Intel® 810 Chipset Family: 82810/82810-DC100 Graphics and Memory Controller Hub (GMCH)

Specification Update

January 2001

Document Number: 290659-003

1. Changed: GMCH Graphics Controller Register Memory

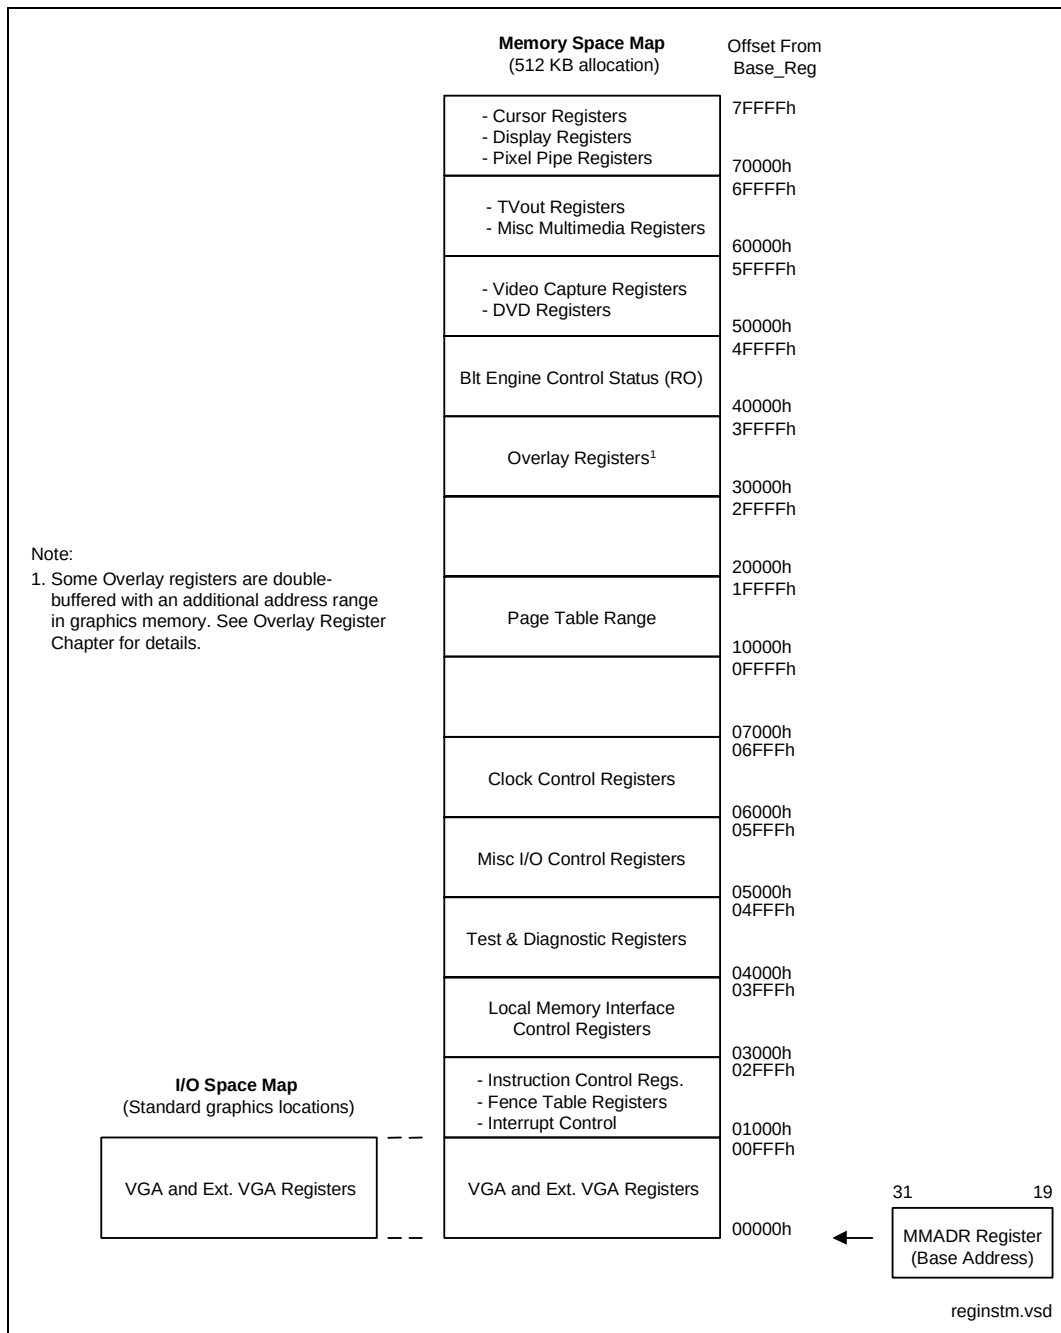
Figure 6 (*GMCH Graphics Register Memory Address Space*), Section 4.1.1.2, Extended Memory Area, is replaced with the figure below.
